Staff Report to the Technical Review Committee November 3, 2015

SUB2015-00051 ITEM # S1 TRC DRAFT

Request for a Major Subdivision plat to combine the existing commercial parcels into one for the proposed Orlando Police Department Crime Scene Operations and Equestrian Center.

BOUNDARY SURVEY

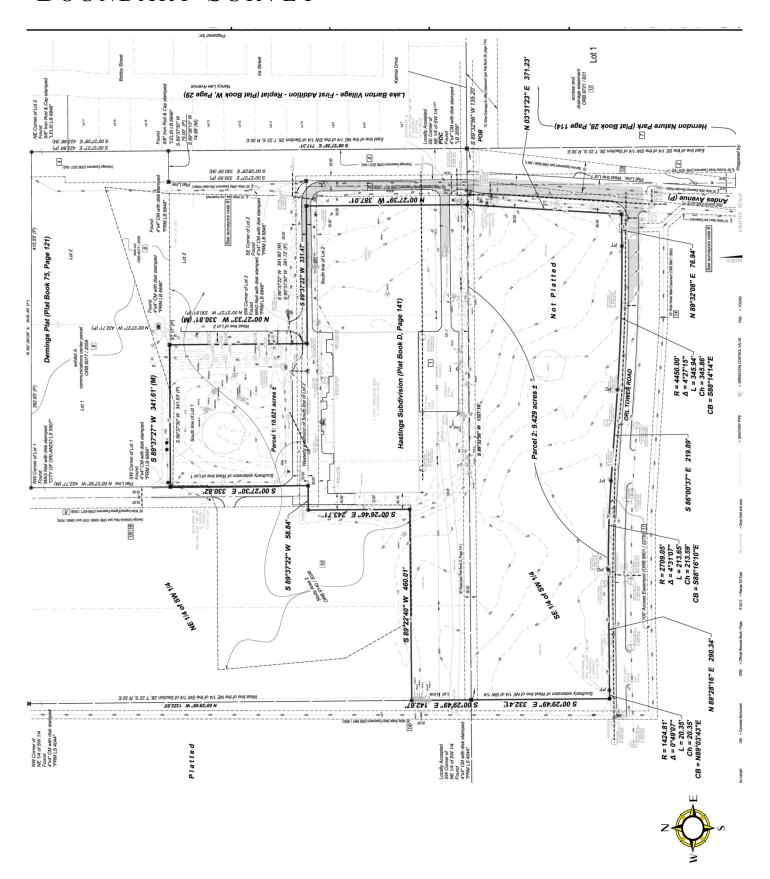
- 1. The plat you have submitted for the first time called Williams Mina a Replat has not passed the review process for the following reasons:
 - 1. Sheet: (Survey) The raised seal is missing and the signature needs to be changed ink.

- 2. Sheet: (Survey) The sanitary line location is missing at CL of George DeSalvia Way east of lot 1 with all as built information pertaining.
 - 3. Sheets: (Survey & Plat) George DeSalvia Way and recording information is missing on the east/west portion.

- 4. Sheet: (Plat) The distance of the west line on lot 2 is a typo.
 - 5. Sheet: (Survey) The text size needs to be corrected to minimum size of .10".

PROPOSED PLAT

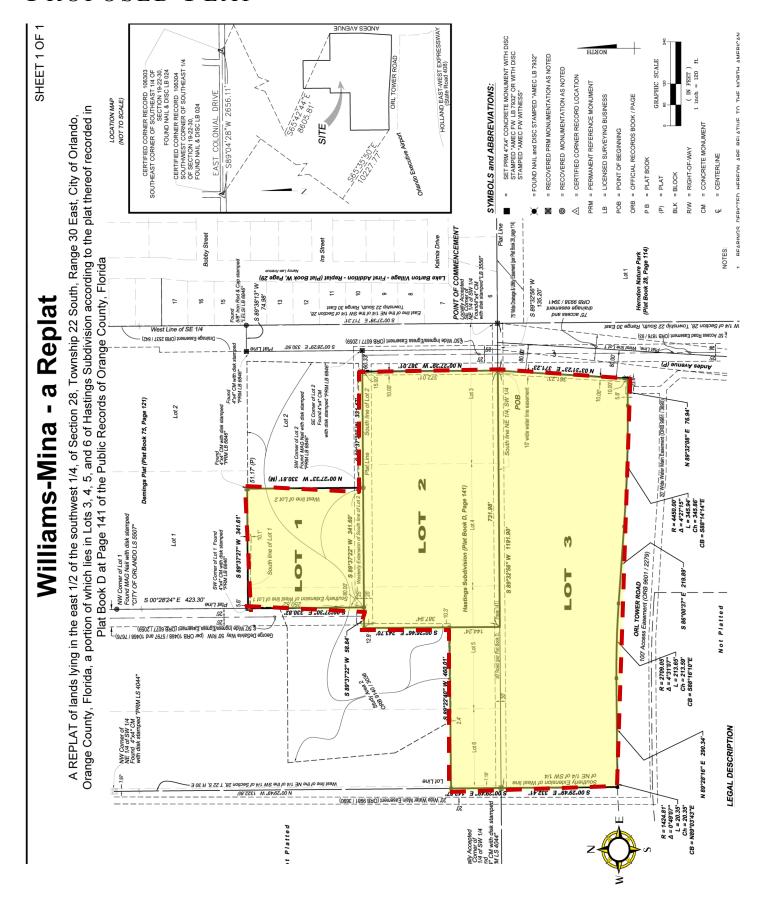
- 6. Sheet: (Plat) The 30' Road (per Plat Book D Page 141) needs to be removed, with the replat.
 - 7. Sheet: (Plat) Change the Water Line Easement language to Utility Easement Per Plat along lots 2 & 3 and add it to the dedication.

- 1. Plat Revision. The Replat sheet 1 of 1 does not appear to depict a utility easement for the existing sanitary sewer and proposed sanitary sewer main relocation. Clarify the need for a utility easement.
- 2. Plat Revision. Place George Desalvia Way into a tract to be maintained by the City.
- 3. GOAA Review. Plat name approved. Please also submit to GOAA for review.
